**Comments on the  
Addendum  
for the  
North Bala Falls Small Hydro Project  
Technical Report**

On behalf of SaveTheBalaFalls.com, we submit these comments on the Addendum for the proposed north Bala small hydro project.

In an Addendum dated May 25, 2012, the proponent for the proposed hydro-electric generating station at the Bala Falls provides some information on a New Proposal which they refer to as Alternative 1D. Where this Addendum is silent, reference will be made to the proponent's Environmental Screening Report (ESR) dated October 2009.

**Drawing 2 – Cropped and rotated section of Figure 2.1 of Addendum (New Proposal), shows tailrace substantially closer and angled towards north falls**

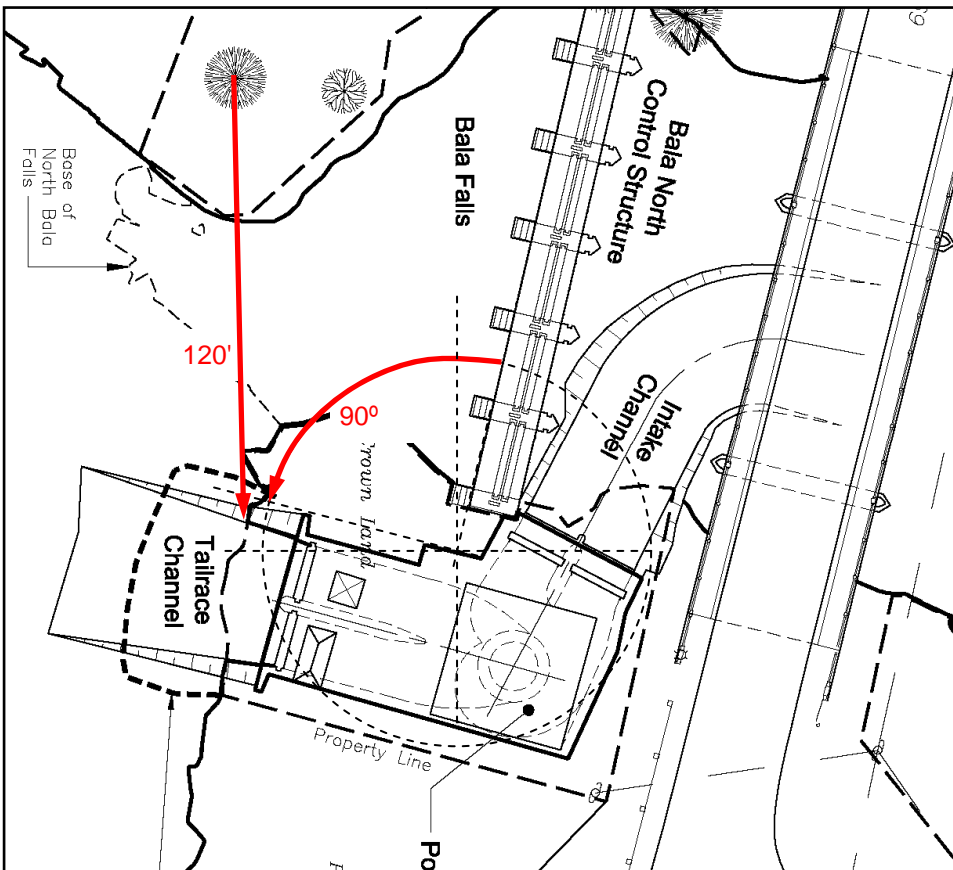
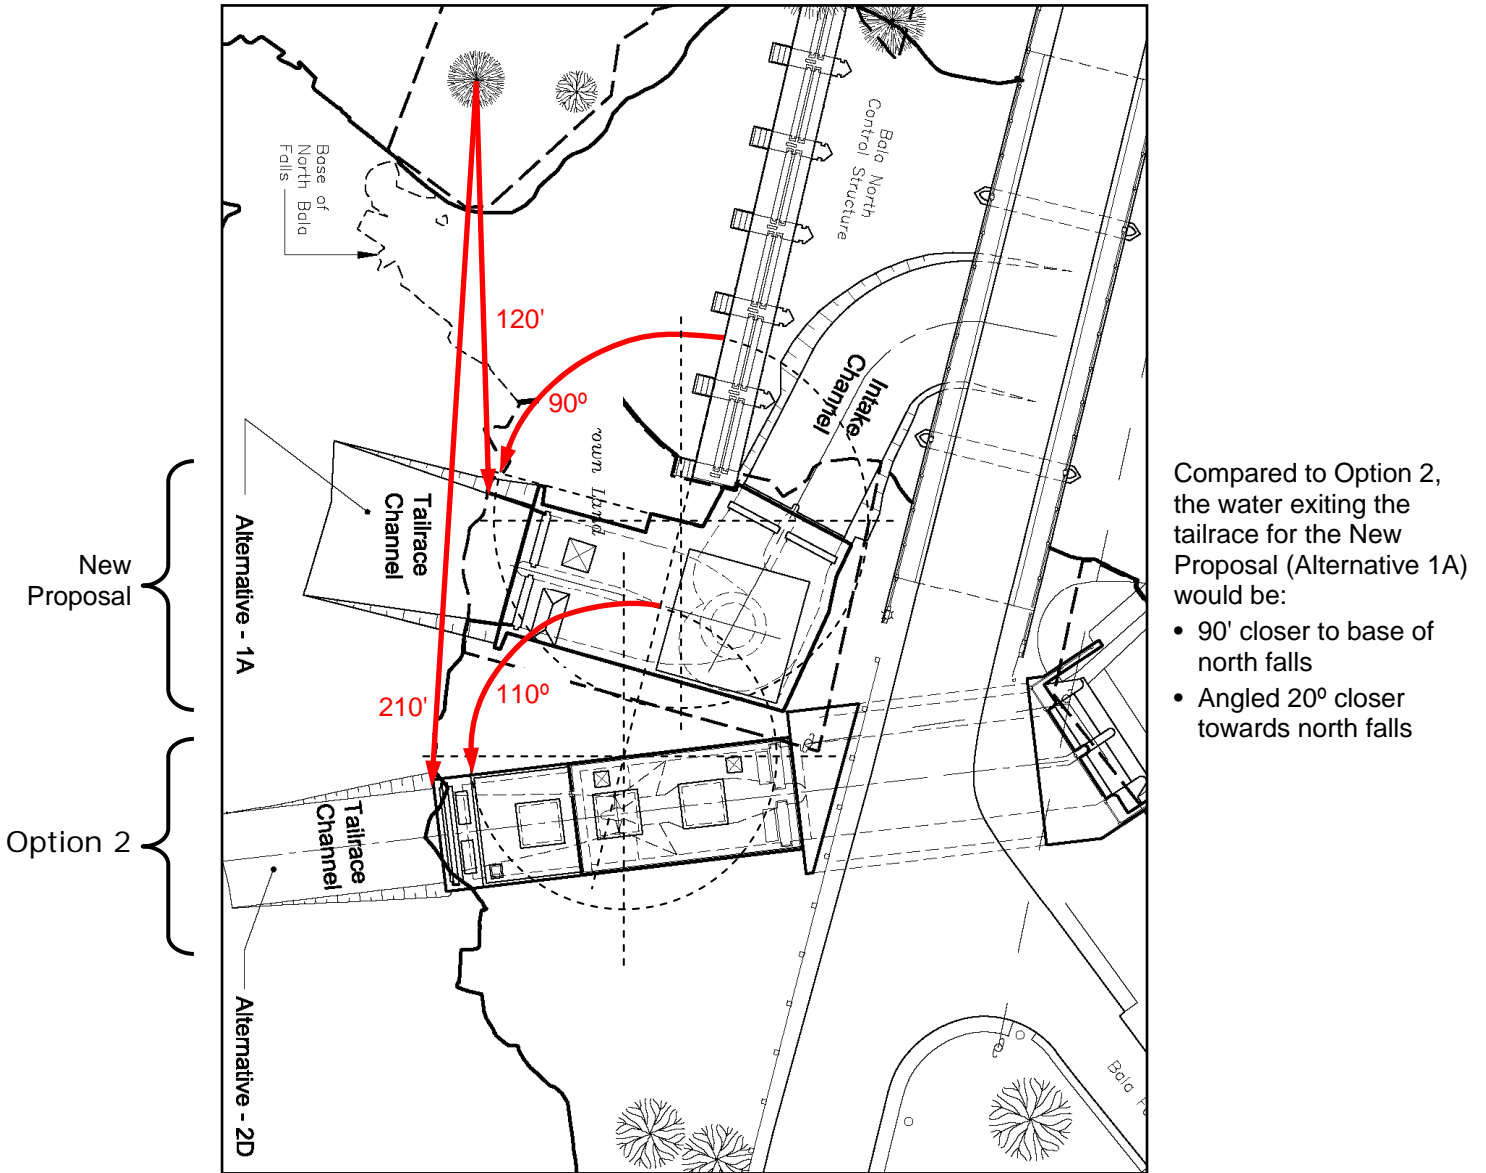
- 1) The location of the tailrace and the direction of water exiting it would be substantially different for the proponent's New Proposal as compared with their previous proposals, as detailed below:
  - a) As shown in Drawing 1 and Drawing 2, compared to the proponent's original Option 1 proposal, the New Proposal would be:
    - More than 60' closer to base of north falls
    - Angled 45° closer towards north falls
  - b) As shown in Drawing 3, compared to the Option 2 proposal, the New Proposal would be:
    - 90' closer to base of north falls
    - Angled 20° closer towards north falls

- 1) For Option 1 the proponent noted "*safety issues and public concern*", yet their New Proposal would be even closer to and more angled towards the north falls (as shown in Drawing 1 and Drawing 2).

*To Report 2: How both the safety issues the proponent noted in their ESR, and the greater safety issues due to the tailrace being closer to the north falls and angled towards them, would be addressed.*

Compared to Option 1, the water exiting the tailrace for the New Proposal (Alternative 1A) would be:

- More than 60' closer to base of north falls
- Angled 45° closer towards north falls

*To Report 1: The tailrace flow simulation needs to be extended and shown for various flow conditions of the north falls, through the proposed powerhouse, and of the flow through the south channel.*

Drawing 3 – Cropped and rotated section of Figure 5.1 of Addendum (New Proposal and Option 2)

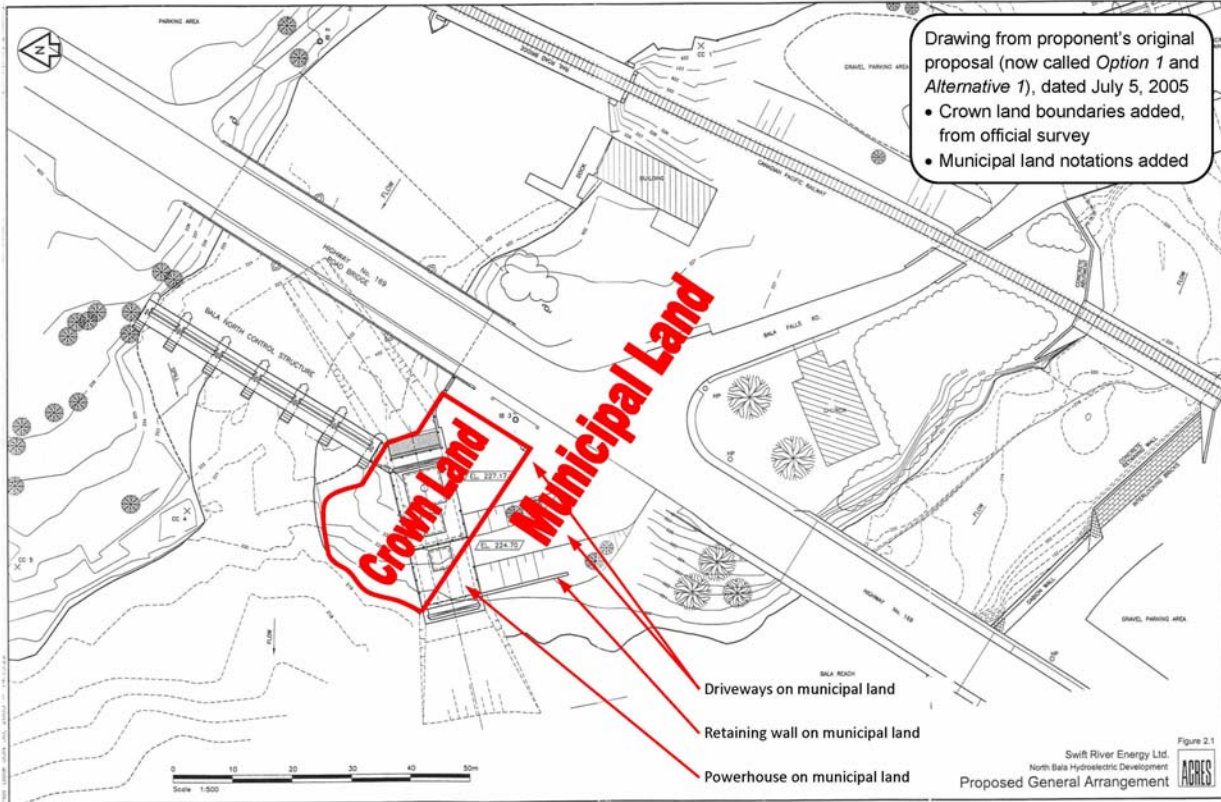
As shown in Drawing 3, the New Proposal would have a different tailrace location and flow direction from that previously proposed.

The resulting different harmful alteration, disruption, or destruction of fish habitat has not been evaluated.

*To Report 24: Scientific study of the impact on fish habitat of the different tailrace location and flow direction.*

**Drawing 4 – From proponent's 2005 proposal, Option 1 would not fit solely on Crown land**

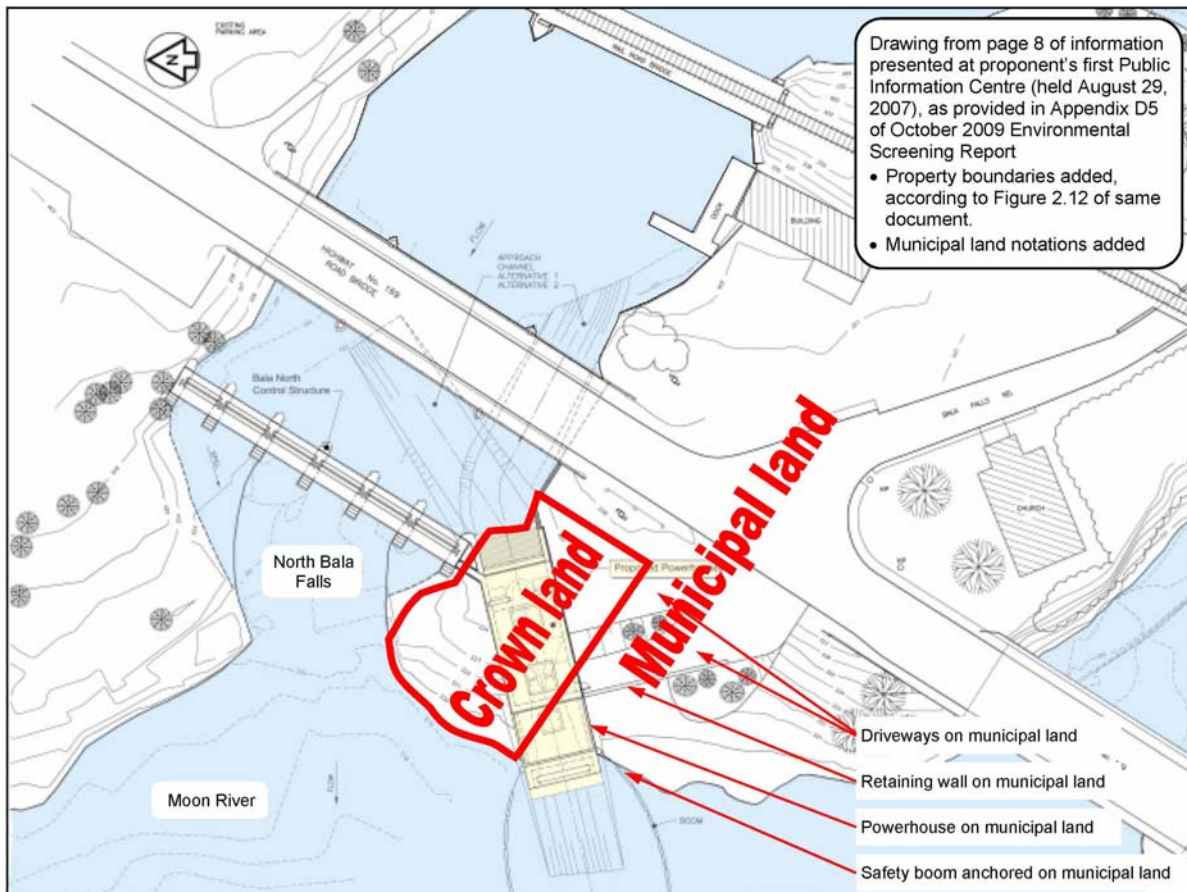
The proponent's statement is not true. The actual drawings presented in the proponent's original 2005 proposal, at their 2007 public information centre, and in the proponent's 2009 environmental screening report as the "original design" are reproduced as Drawing 4, Drawing 5, and Drawing 6.

As can be clearly seen from the added property boundary lines in these three drawings, municipal land was needed for all of the following:

**Drawing 7 – View westward from District Road 169 at Crown land highway frontage, shows viewing obstruction to looking north created by end of highway bridge railing**

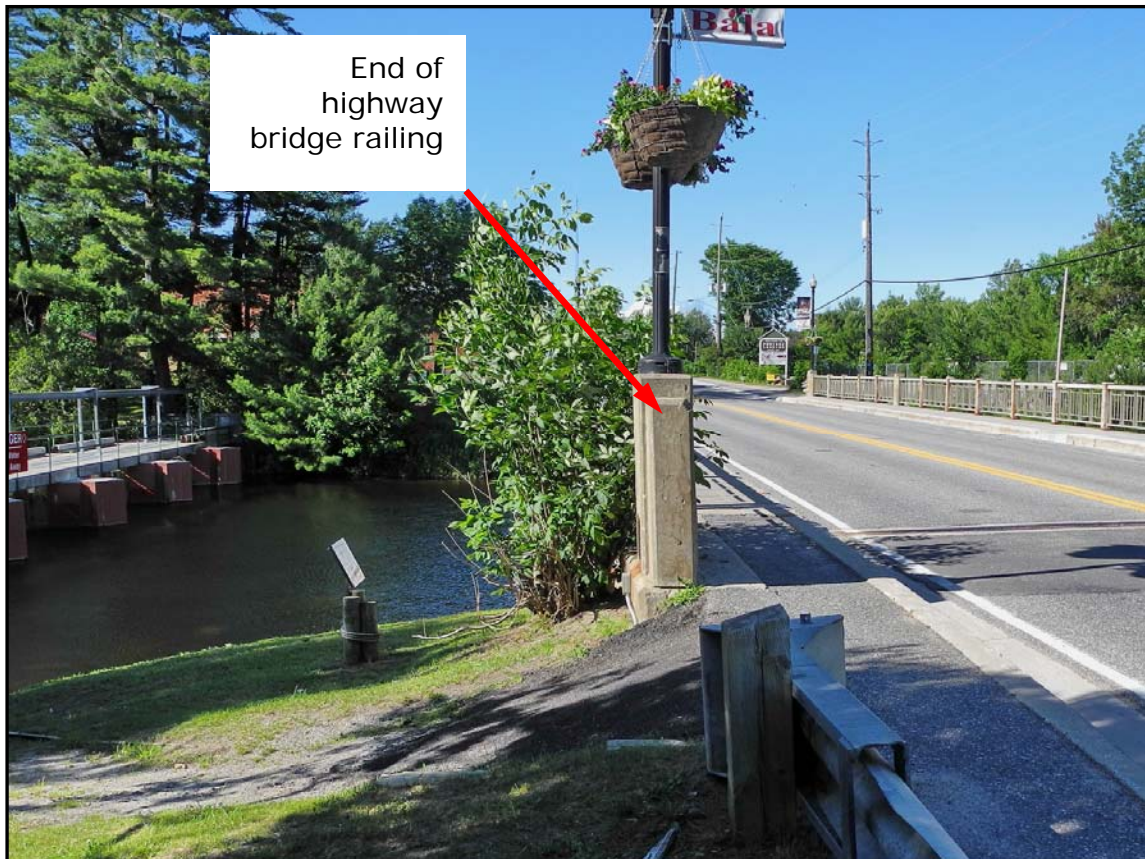
During operation, the proponent's New Proposal would require a driveway for service vehicle access and this driveway would need to access District Road 169. As shown in Drawing 7, the Crown land's frontage to District Road 169 is approximately 12.8 m wide (42') and even if the driveway was located at the south property boundary:

- 1) The concrete end of the highway bridge railing would obstruct the view of southbound drivers to see vehicles attempting to exit this driveway.
- 2) The concrete end of the highway bridge railing would obstruct the view of drivers exiting this driveway to see southbound vehicles approaching from the north (as shown in Drawing 8).

To Report 33: How service vehicles could safely exit the New Proposal’s driveway. 13
